SIB 61 02 20

KNOCKING NOISE FROM WASHER FLUID RESERVOIR

This Service Information Bulletin (Revision 1) replaces SI B61 02 20 dated March 2020.

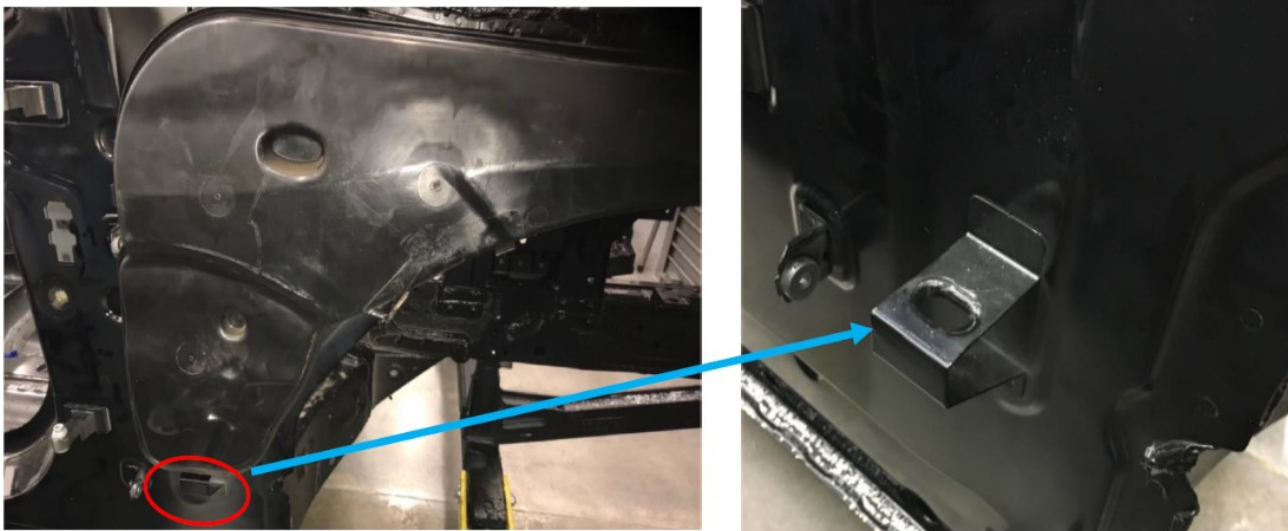
When driving over uneven pavement or cobblestones, a knocking noise is present from the passenger side front area (A pillar). Once the vehicle is driven on a flat, even surface; the noise is no longer present.

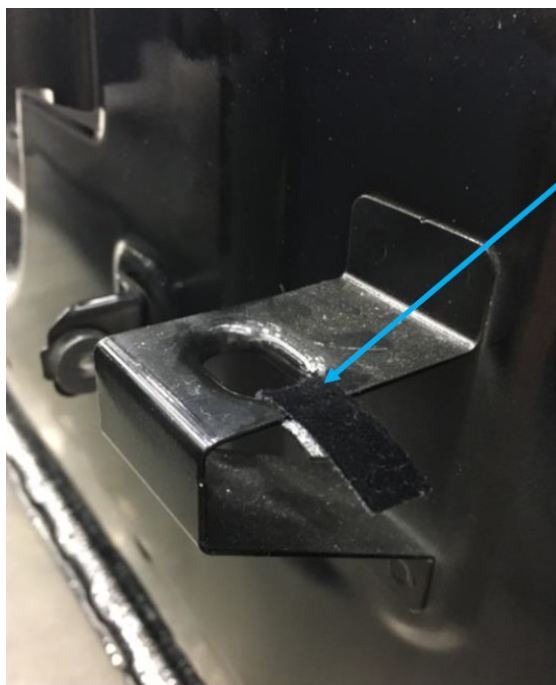
2. Access the lower mounting bracket.

3. Wrap the lower mounting bracket with felt tape as shown.
